DEPARTMENT OF TRANSPORTATION
NATIONAL TRANSPORTATION SAFETY BOARD
WASHINGTON, D.C. 20591

SB-1-96

During our investigation of the midair collision between Beech Baron, N6127, and TWA DC-9, N1063T, near Urbana, Ohio, a series of photographs were taken for us by your NAFEC facilities from inside the cockpit of a TWA DC-9 and an FAA Beech Baron. In reviewing the photographs of the Beech Baron, it was noted that a considerable portion of the window area can be blanked out by the sun visor.

BEECHCRAFT BARON B-55
 AIRCRAFT ATTITUDE - LEVEL
 CAMERA ATTITUDE - NORMAL
 PILOT'S EYE LOCATION TO SUIT CAB
 EYE LOCATION
 32 1/4" ABOVE SEAT RAILS
 5" AFT REARMOST CONTROL COLUMN MOVEMENT WITH SUN VISORS EXTENDED

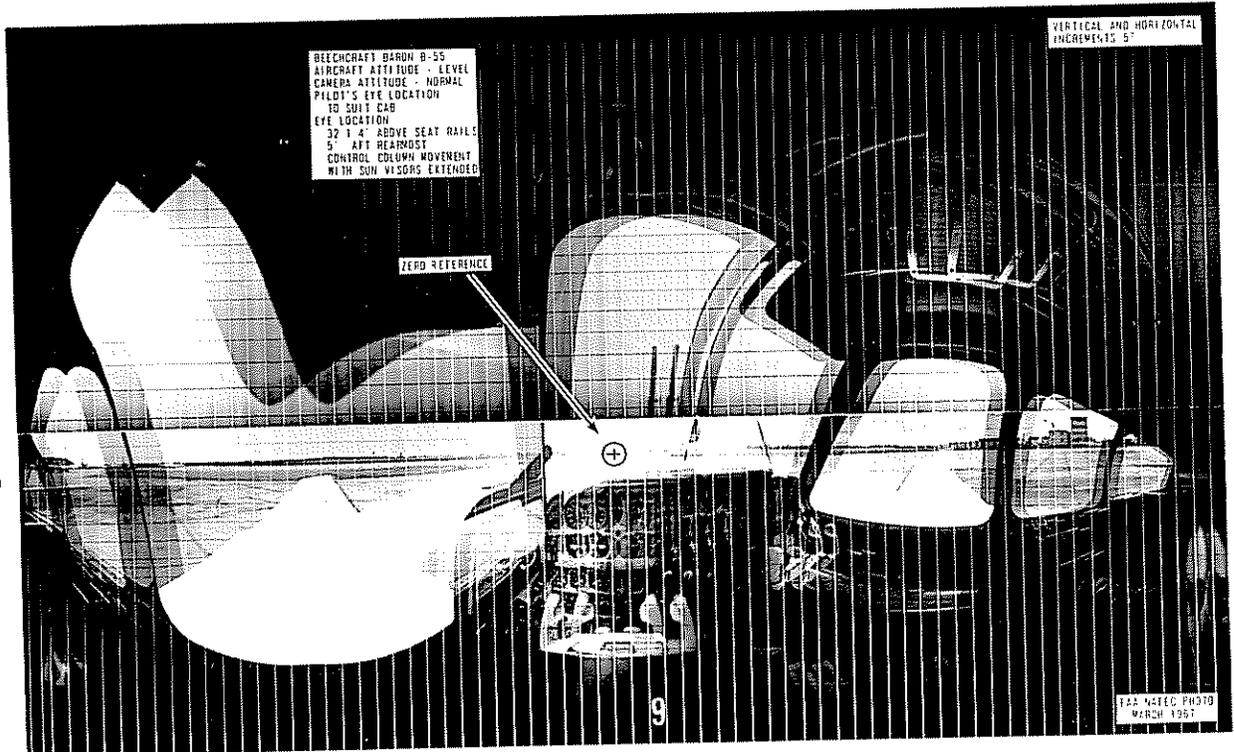
We realize that there are no minimum standards depicting angular limits applicable to an airplane certificated under the provisions of Part 23 of the Federal Aviation Regulations and that the sun visor positioned in its most adverse position would not have hindered the pilot in detecting the DC-9 in the aforementioned accident. However, due to the ever increasing collision hazard, we believe that so long as collision avoidance is dependent on visual detection even those airplanes which provide excellent visibility should not be equipped with objects that seriously diminish the angles of vision of the pilot. Although it is necessary to provide protection to the pilot from the direct rays of the sun, we believe that a see-through visor should be provided rather than a solid visor which cuts out the vision entirely.

We recommend, therefore, that the Federal Aviation Administration survey the types of general aviation airplanes equipped with solid type visors to determine the extent of the resultant vision impairment. Where it is found that they severely hinder the pilot's vision, the solid visor should be replaced by a see-through type. Additionally, we recommend that, if this survey shows the solid type visors adversely affect the visibility from the aircraft, Part 23 be amended to provide

that when a sun visor is installed on future airplanes, it be a see-through type if it can be positioned so that it extends into the area of vision necessary for collision avoidance.
